EASE Reply to ENTSO-E Public Consultation on “All Continental European and Nordic TSOs’ proposal for a Cost Benefit Analysis methodology”

February 2018

Figure 1. Example of Monte Carlo Simulation results without considering dependency and taking into consideration dependency

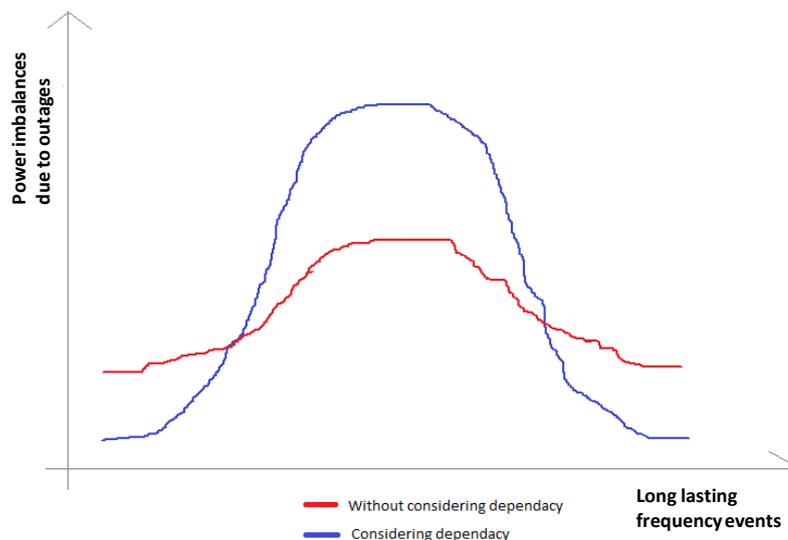
The methodology proposed by ENTSO-E does not take into account the correlation between the long lasting frequency deviation events and the power imbalance due to outages. If this correlation is not taken into consideration, the volatility of Monte Carlo simulation outputs will be higher, producing some weird results during the simulation process (non-relevant incident could cause important outages and vice versa):

The results of not taking into account the dependency could lead to a higher probability of large impact due to the incidents. This higher impact is relevant to establish the FCR

size and its activation period, increasing the period which is obtained in order to fulfil the security criteria.

There are some non-complex analytic approaches to include the correlation among the several in this simulation process to take into consideration the dependence. Finally, the assessment approach assumes that the requirements of reservoir up and down are equivalent.
